Canyon Fuel
Company, LLC.
Skyline Mine

RE: Winter Quarters As-built modifications, Canyon Fuel Company, LLC, Skyline Mine, C/007/005,

WINTER QUARTERS VENTILATION PAD
ROAD AND DRAINAGE DETAILS

WINTER QUARTERS VENTILATION PAD
FACILITIES AS-BUILT PLAN

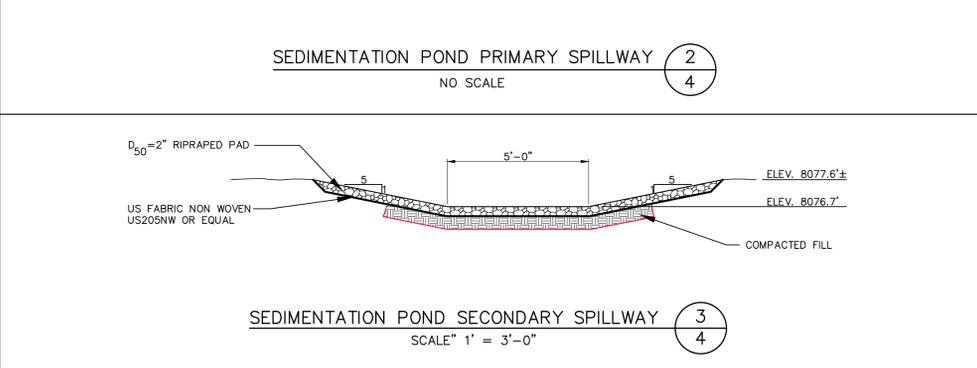
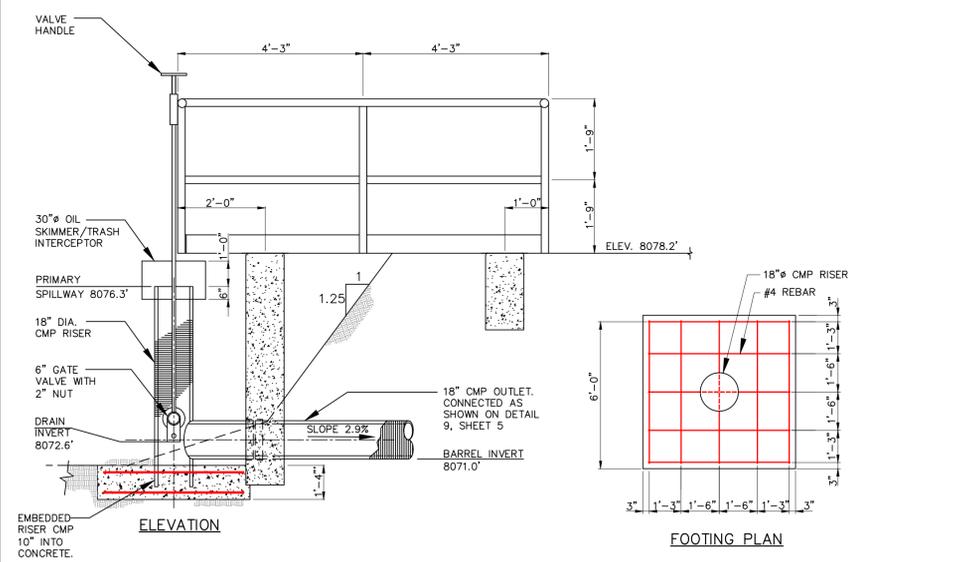
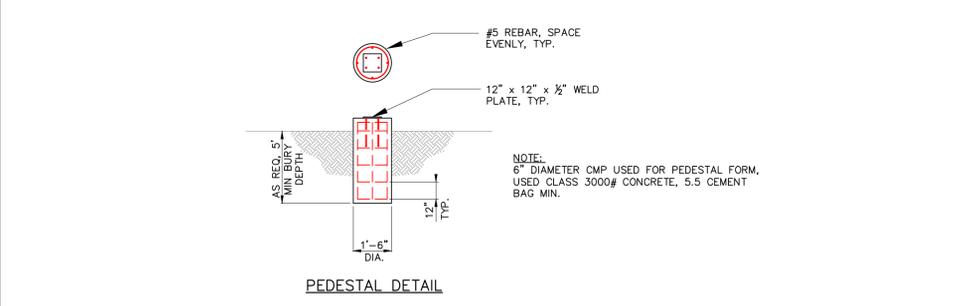
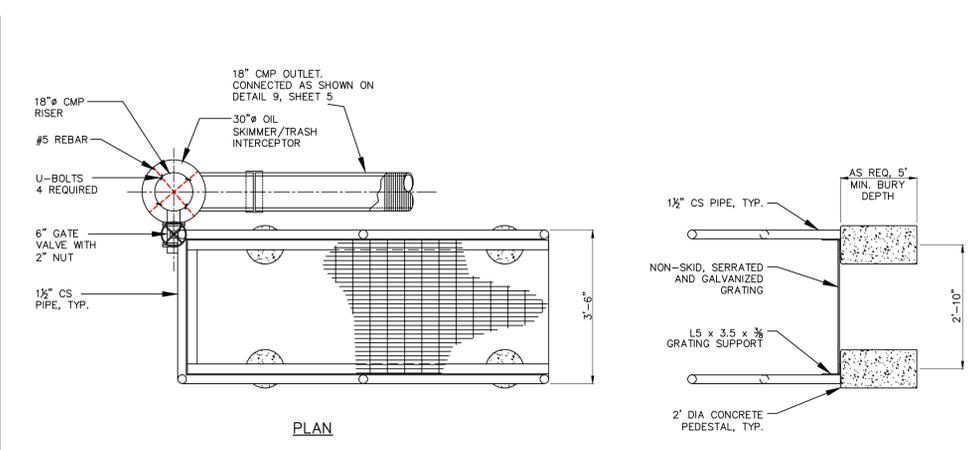
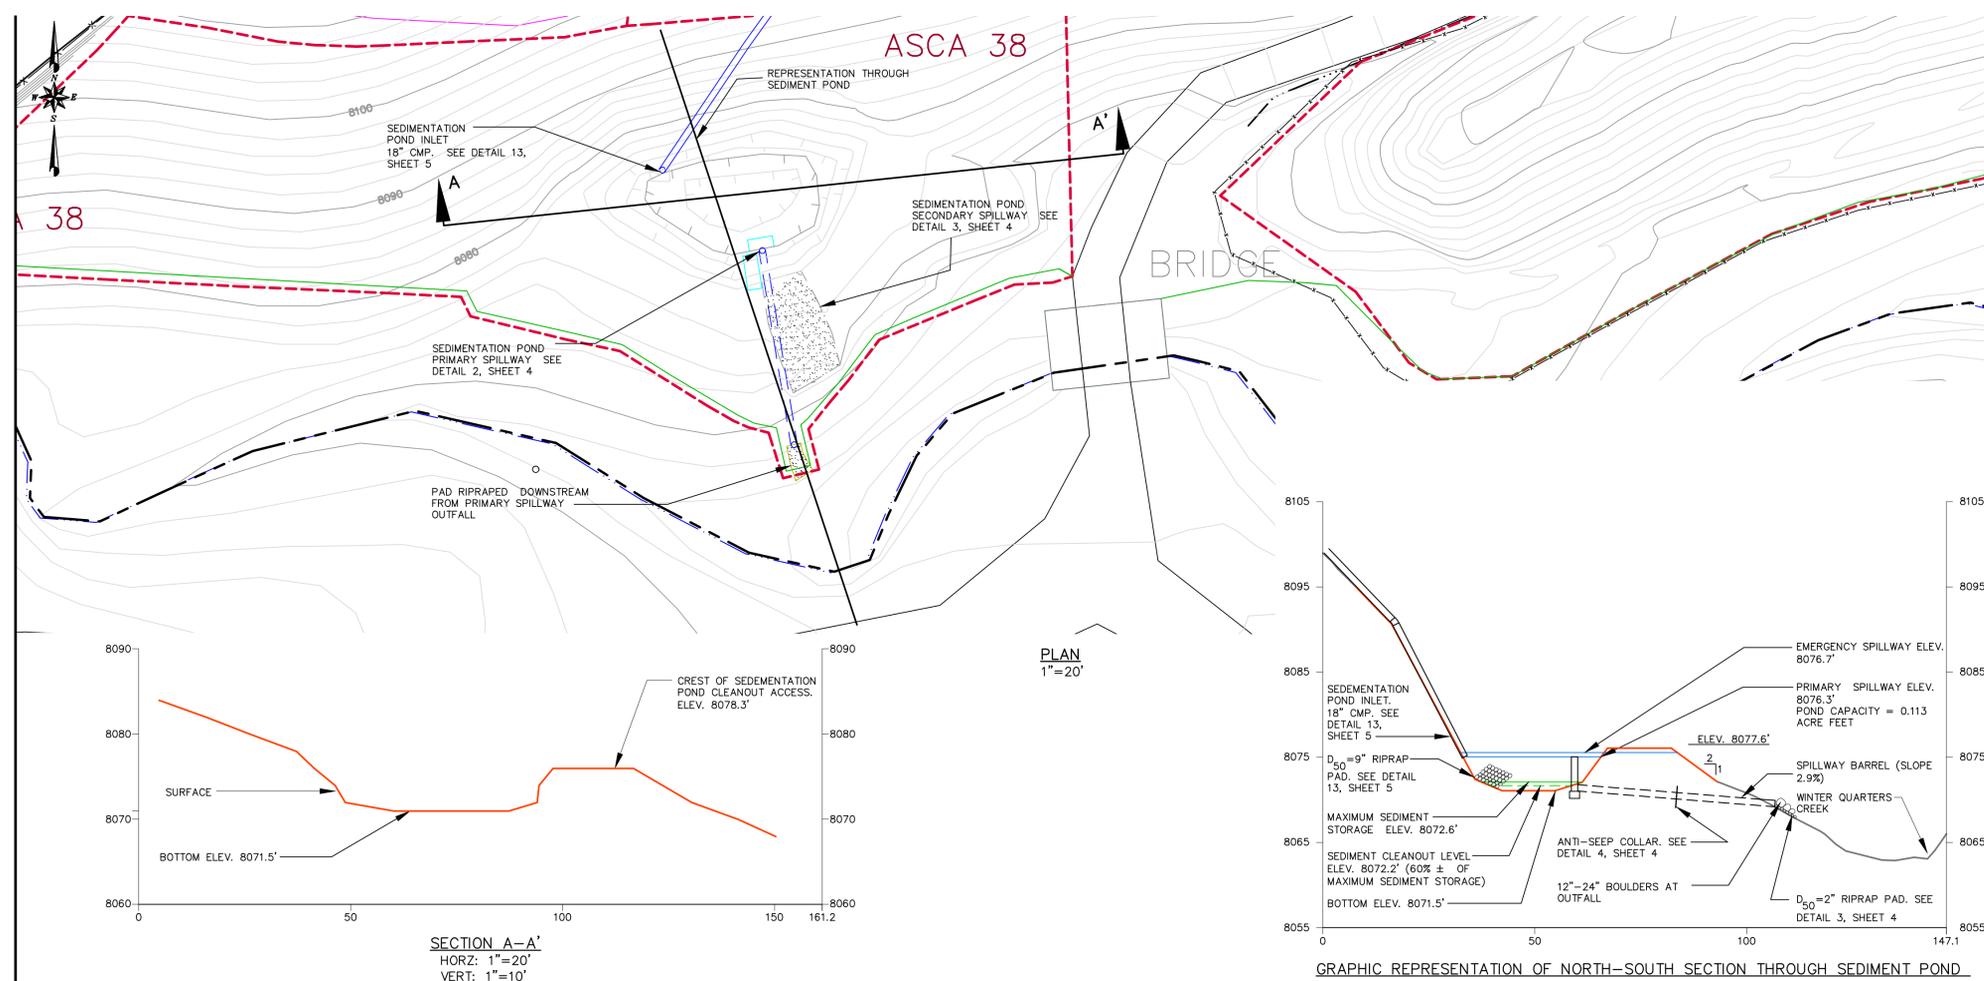
DATE	No.	REVISIONS
12/11	1	Modified detail 7 from berm to jersey barrier

WINTER QUARTERS VENTILATION PAD
SEDIMENTATION POND AS-BUILT,
SECTIONS AND DETAILS

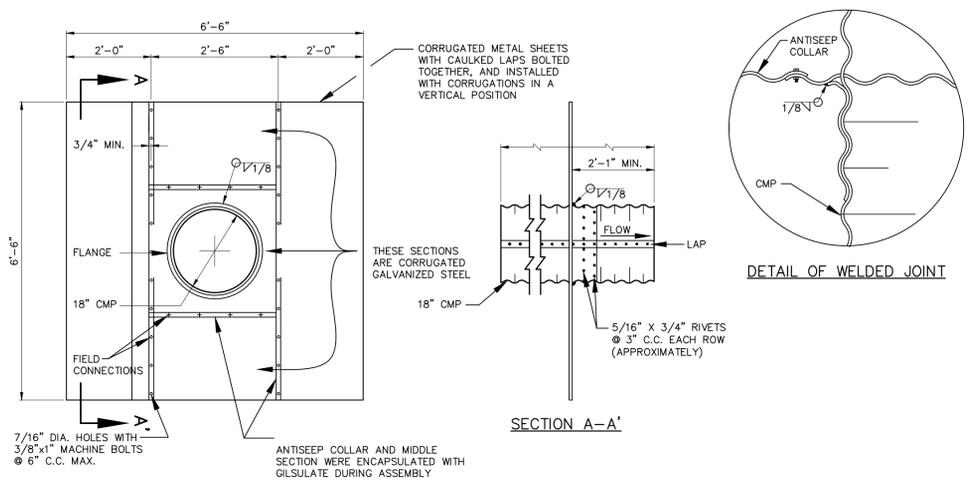
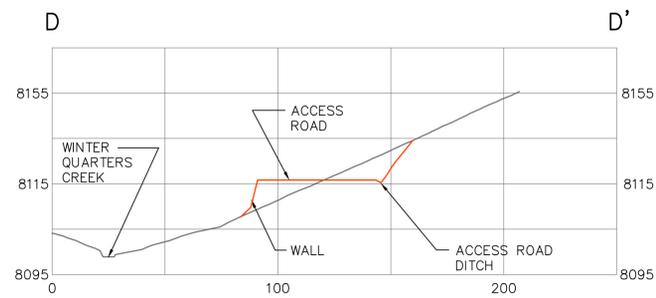
The proposed modifications to Plate 2.3.4-3A include as-built modifications to the pad, sedimentation pond, topsoil pile, and other minor modifications as they relate to the actual construction of the site. Temporary features necessary for the construction of the slope are also identified on the plate. Plates 3.2.4-3C, 3.2.4-3D, and 3.2.4-3E provide detailed as-built modifications as identified in the revision block of the respective drawings.

DATE	No.	REVISIONS
12-22-11	1	As-built modifications

WINTER QUARTERS VENTILATION PAD
OPERATIONAL SURFACE CROSS SECTIONS

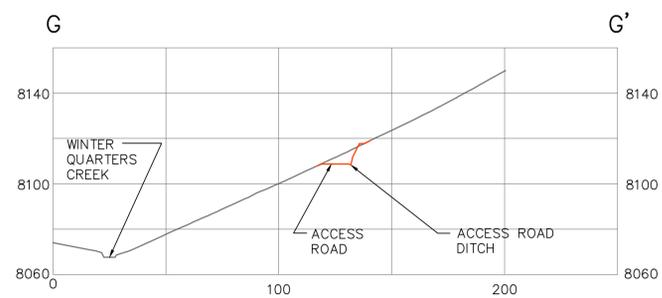
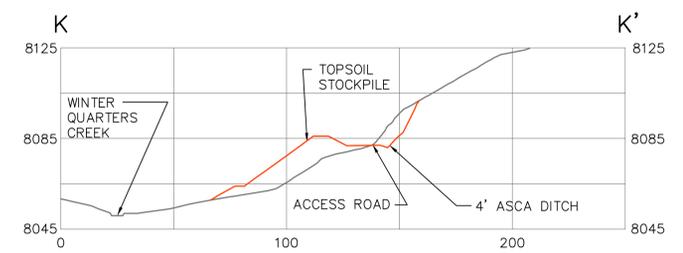
DATE	No.	REVISIONS
12-22-11	1	As-built modifications

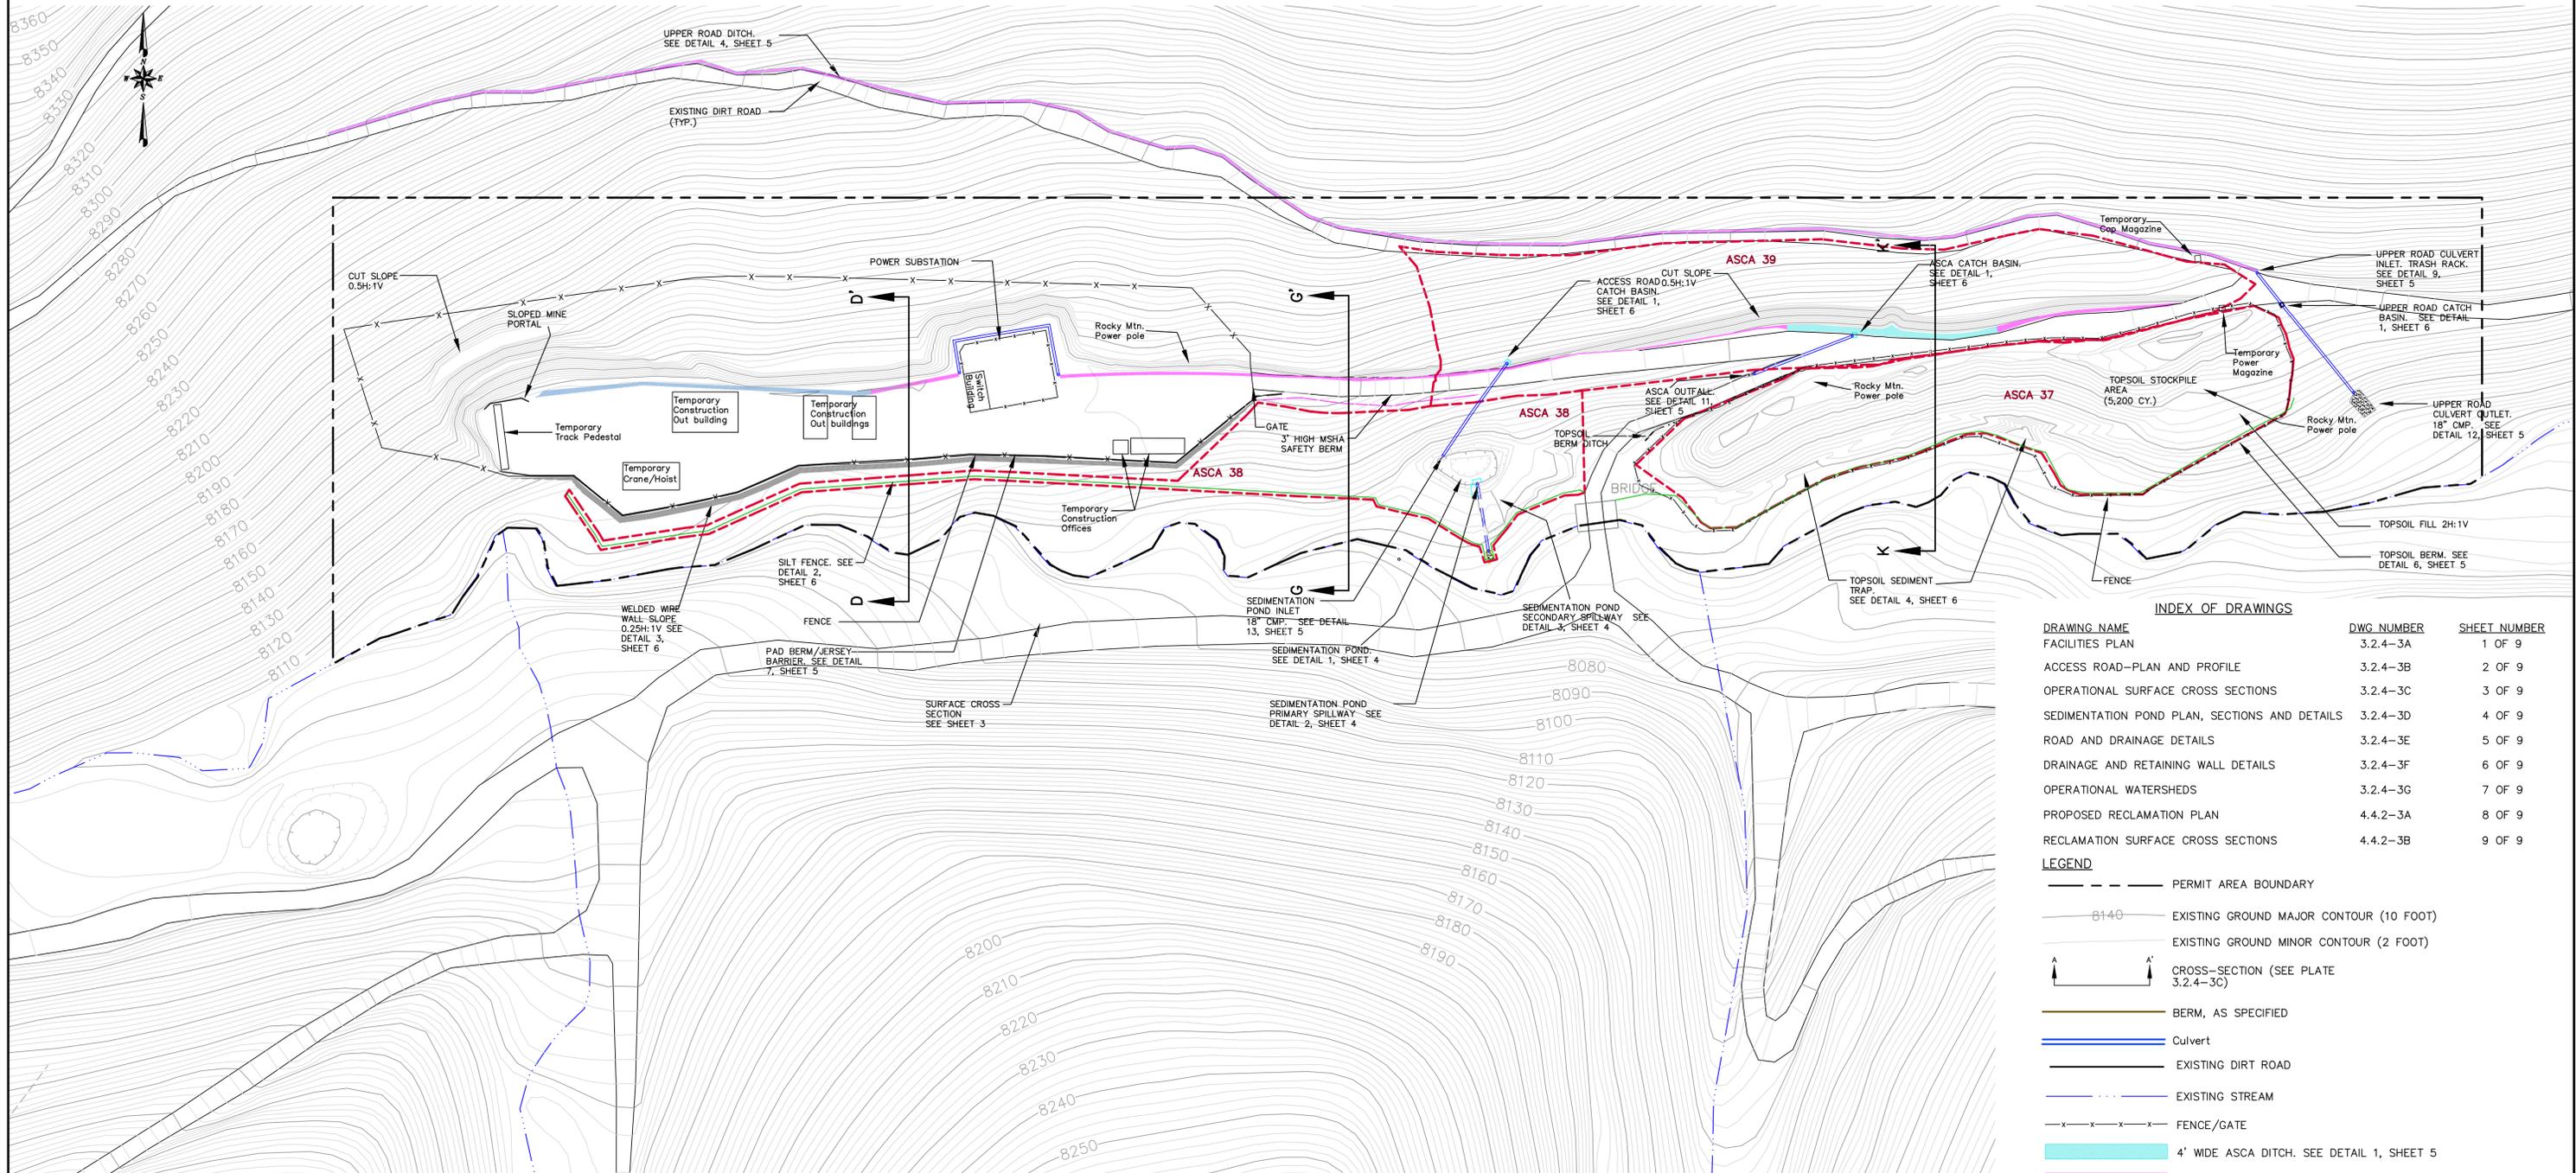
DATE	No.	REVISIONS
10-4-11	1	Added Temporary Powder and Cap magazines and temporary construction buildings
2-21-11	2	Provided As-built modifications
